PCN# 20191112001.1
Qualification of RFAB as an additional Fab site option for select devices and Datasheet Update
Change Notification / Sample Request

PCN Number:	20191112001.1	**PCN Date:**	Nov 18, 2019
Title:	Qualification of RFAB as an additional Fab site option for select devices and Datasheet Update		
Customer Contact:	PCN Manager	**Dept:**	Quality Services
Proposed 1st Ship Date:	Feb 18, 2020	**Estimated Sample Availability:**	Date provided at sample request.

SLVS916I – JULY 2010 – REVISED OCTOBER 2019

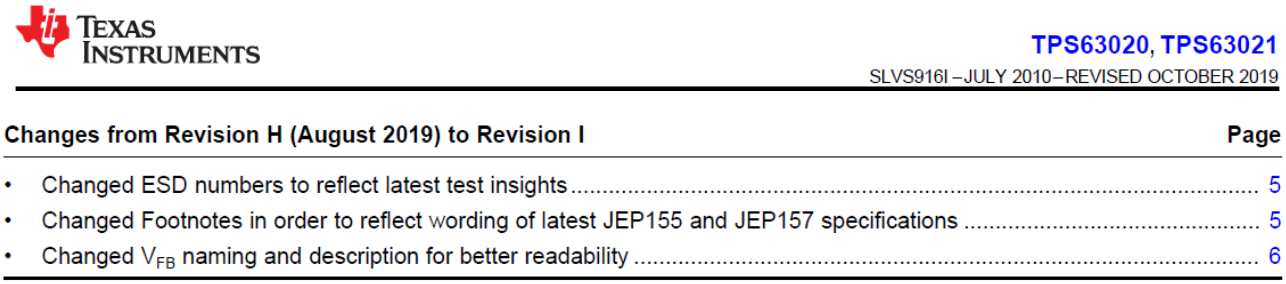
As part of the RFAB qualification, it was determined that the previous Datasheet ESD limits were not accurate (this is also true for FFAB). This has been corrected and the datasheet number will be changing as shown below:

Changes from Revision H (August 2019) to Revision I **Page**

- Changed ESD numbers to reflect latest test insights 5
- Changed Footnotes in order to reflect wording of latest JEP155 and JEP157 specifications 5
- Changed V_{FB} naming and description for better readability 6

Device Family	Change From:	Change To:
TPS63020, TPS63021	SLVS916H	SLVS916I
